PILATUS AIRCRAFT LTD. STANS, SWITZERLAND

SERVICE BULLETIN

Service Bulletin No: 27-005 Ref No: 223

FLIGHT CONTROLS - FLAPS - FLAP ACTUATOR - PUSHROD ASSY INSPECTION FOR INCORRECTLY INSTALLED TAPER PINS AND POSSIBLE REWORK

Pushrod Assy - Removal and Installation Figure 1

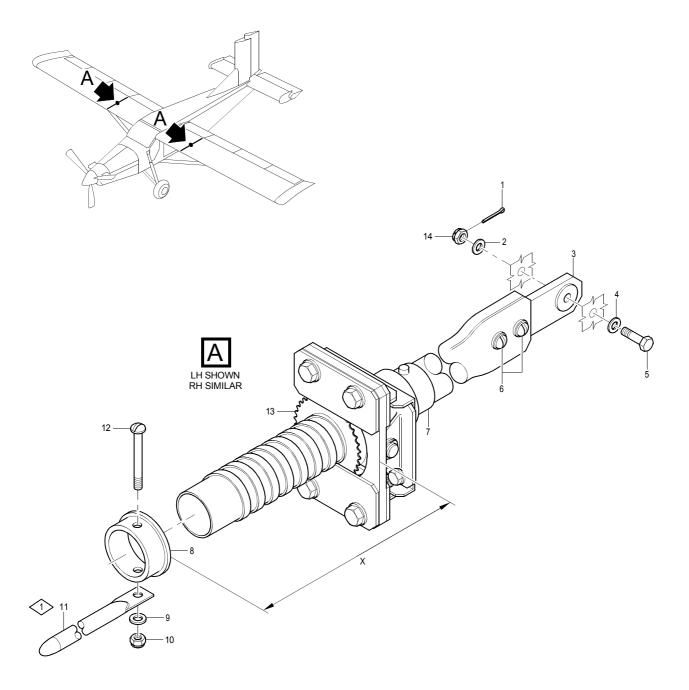
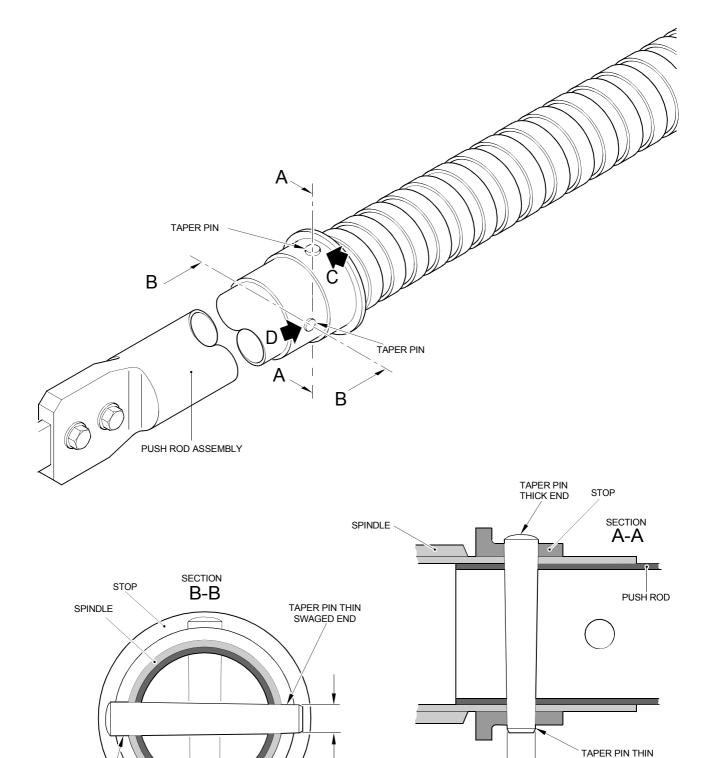
- (1) Extend the flaps.
- (2) Move the handle of the drive assy back until you hear one or two audible clicks. This is to release the spring load of the flap chain. This is necessary to remove the pushrod assy (7) only (without removal of the full flap actuator assy).

- (5) Support the LH flap.
- (6) Record the details that follow. They are needed for when you install the pushrod assy (7) again:
 - (a) Measure Dimension X (the distance between the stop (8) and the guide).

- (b) Make a note of the angular position of the head of the screw (12).
 - (c) Make a note of the angular position of the head of the screws (6).
- (7) On the LH flap actuator, remove the cotter pin (1), the nut (14), the washers (2) and (4) and the bolt (5).

- (8) Remove the nut (10), the washer (9) and the screw (12).
- (9) On the LH wing only, remove the flap position indicator (11).
- (10) Remove the stop (8).

- (11) Turn the pushrod assy (7) counter clockwise and remove it from the rear of the wing. You must make a note of the angular position of the head of the screw (6) immediately:
 - As the screw jack of the pushrod assy (7) is released from the sprocket assy (13).
- (12) Do Steps 3.A.(5) thru (11) for the RH wing.

- (1) Apply grease (Material No. P04-006) to the spindle threads of the of the pushrod assy (7).
- (2) Support the LH flap.
- (3) On the LH wing, install the pushrod assy (7) into the wing from the rear.

- (4) Hold the pushrod assy (7) with the head of the screw (6) at the same angular position as you recorded during Step 3.A.(11).
- (5) Turn the pushrod assy (7) clockwise to engage it with the sprocket assy (13) until you can install the stop (8).

- (8) Install the washer (9) and the nut (10).
- (9) Turn the pushrod assy (7) until the distance between the stop (8) and the guide is the same as Dimension X recorded during Step 3.A.(6)(a).

- (10) Make sure that the end plate (3) of the pushrod assy (7) is vertically aligned with the fasteners horizontally aligned as shown in Fig. 1.

- (11) Make sure that the heads of the screw (6) and the screw (12) of the pushrod assy (7) are at the same angular position that you recorded during Step 3.A.(6)(b) and (c). If not, you must proceed as follows:

Pushrod Assy - Inspection and Rework of Taper Pin Installation Figure 2 (Sheet 1 of 3)

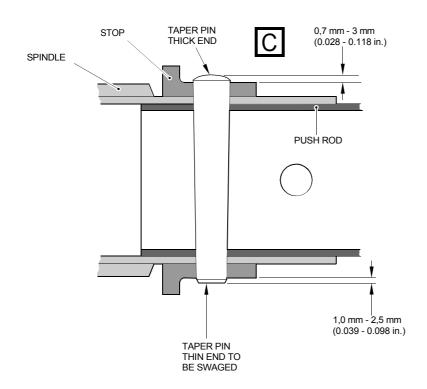
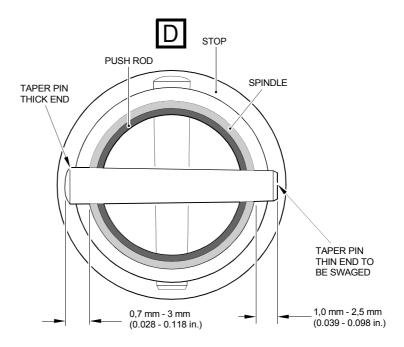
- (1) Fully clean the spindle, the stop and taper pin heads with absorbent paper (Material No. P02-031) made moist with solvent (Material No. P01-008) on each pushrod assy.
- (2) Examine the two taper pins installed in each pushrod assy:
 - (a) Damaged or unserviceable taper pins must be replaced. If necessary, cut or drill out the swaged end to remove the damaged taper pin and swage a new taper pin in position (refer to Step 3.C.).
 - (b) Do a check that the thin end of each taper pin has been swaged.
 - (c) If necessary, measure the diameter of the thin end of each taper pin (Ref. Fig. 2, Sections A-A and B-B):
 - The minimum diameter is 5,15 mm (0.203 in.)
 - If the diameter is less than 5,15 mm (0.203 in.) the tapered pin has not been swaged correctly. You must do the taper pin swage procedure, refer to Step 3.C.
- (3) Install the pushrod assemblies, Ref. Step 3.D.

- (1) You must only do this procedure for each taper pin that has failed the inspection procedure
- (2) Measure the protrusion of the taper pin at each end (Ref. Fig. 2, Views C and D):
 - The thick end (un-swaged) must protrude between 0,7 mm (0.028 in.) and 3 mm (0.118 in.).
 - The thin end (to be swaged) must protrude between 1,0 mm (0.039 in.) and 2,5 mm (0.098 in.).
- (3) If necessary, remove the taper pin (cut or drill out the swaged end) and install the longer alternative taper pin (P/N 940.29.09.379) and do Step 3.C.(2) again.

- (8) Hold the pushrod assy tightly with the thick end of the taper pin in position on the anvil (Ref. Fig. 2, Sheet 3).
- (9) Use the hammer and the pin punch to swage the thin end of the taper pin as follows:
 - (a) Swage the thin end of the taper pin equally around the circumference to form a slight shroud (Ref. Fig. 2, Sheet 3).
 - (b) Swage the thin end of the taper pin until you get a diameter of between 5,15 and 5,3 mm (0.203 and 0.209 in.). This is to make sure that there is sufficient locking (Ref. Fig. 2, Sections A-A and B-B).

NOTE: The original diameter of the thin end of the taper pin is 5,0 mm (0.197 in.).

5,15 - 5,3 mm (0.203 - 0.209 in.)

Pushrod Assy - Inspection and Rework of Taper Pin Installation Figure 2 (Sheet 3 of 3)

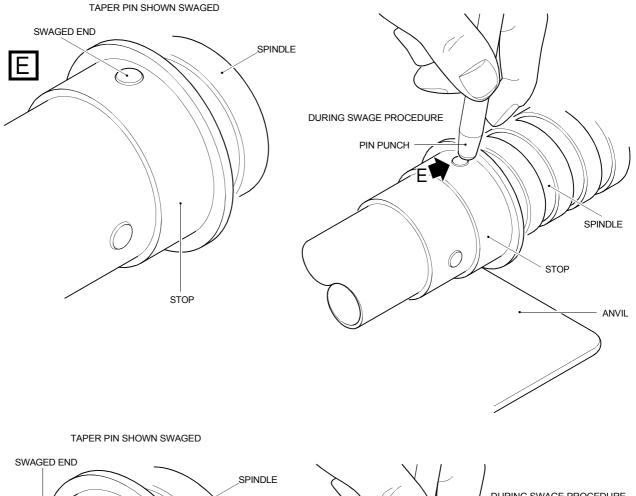
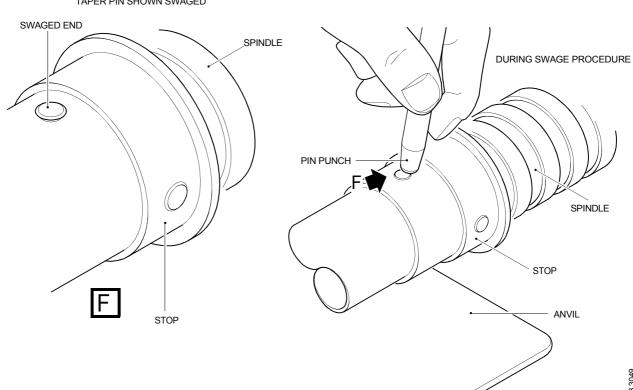
CAUTION: MAKE SURE THAT YOU DO NOT DAMAGE THE SPINDLE OR THE STOP DURING THIS PROCEDURE. ONLY THE TAPER PINS MUST TOUCH THE ANVIL.
